**Committee of Experts on the Transport of Dangerous Goods
and on the Globally Harmonized System of Classification
and Labelling of Chemicals**

Sub-Committee of Experts on the Transport of Dangerous Goods

Listing of Artemisinin and derivatives in 2.5.3.2.4

Transmitted by the experts from China and the European Chemical Industry Council (Cefic)

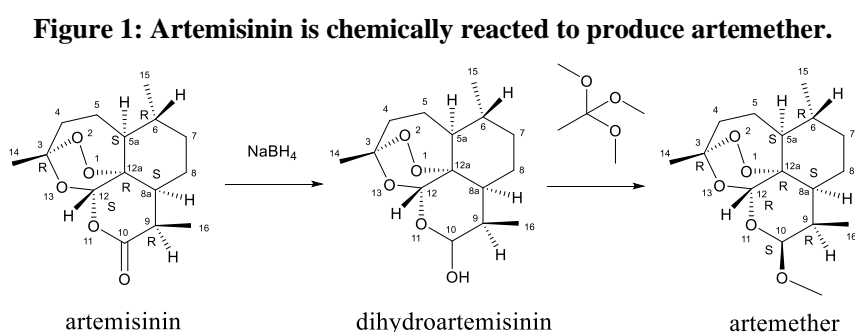
2. At the thirty-eighth session of Sub-Committee of Experts on the Transport of Dangerous Goods, the Sub-Committee adopted the proposal of document ST/SG/AC.10/C.3/2010/53 by including a new entry "[3R-(3R, 5aS, 6S, 8aS, 9R, 10R, 12S, 12aR**)]-DECAHYDRO-10-METHOXY-3,6,9-TRIMETHYL-3,12-EPOXY-12H-PYRANO[4,3-j]-1,2-BENZODIOXEPIN" (UN 3106, organic peroxide type D) to *list of currently assigned organic peroxides in packagings* in *Model Regulations 2.5.3.2.4*. The name of this entry adopts the chemical name of the substance, which is similar to the chemical name of artemether, which is "(3R, 5aS, 6R, 8aS, 9R, 10S, 12R, 12aR)-decahydro-10-methoxy-3,6,9-trimethyl-3,12-epoxy-12H-pyrano[4,3-j]-1,2-benzodioxepin", the difference between the two is the description of the chiral site, The original entry name is inaccurate. Artemether is produced by a chemical reaction of artemisinin (Figure 1).

Figure 2: Other common artemisinin derivatives.

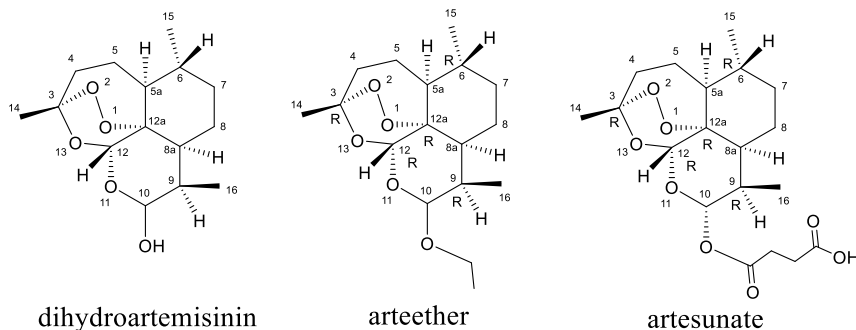
4. The entry "[3R-(3R, 5aS, 6S, 8aS, 9R, 10R, 12S, 12aR**)]-DECAHYDRO-10-METHOXY-3,6,9-TRIMETHYL-3,12-EPOXY-12H-PYRANO[4,3-j]-1,2-BENZODIOXEPIN" in 2.5.3.2.4 needs to be corrected for its inaccurate name. Due to the chemical name is complex and easy to make mistakes when using, consider amending it to a generic name. Considering that artemisinin, artemether and other common artemisinin derivatives have similar molecular structures, all contain peroxide bridges (Figure 2), and exhibit the properties of organic peroxides, in order to facilitate the transportation of these goods, artemisinin or its derivatives are considered to be put into the same entry, classified as UN 3106, organic peroxides type D, packaging method OP7. If the substance has further classification test results according to *Manual of Tests and Criteria*, it shall be classified into the appropriate type based on the test results.

“35) Includes artemisinin, artemether, dihydroartemisinin, arteether, artesunate, and other derivatives with a similar peroxide bridge structures. If further test results are available, it shall be classified appropriately based on the test results.”
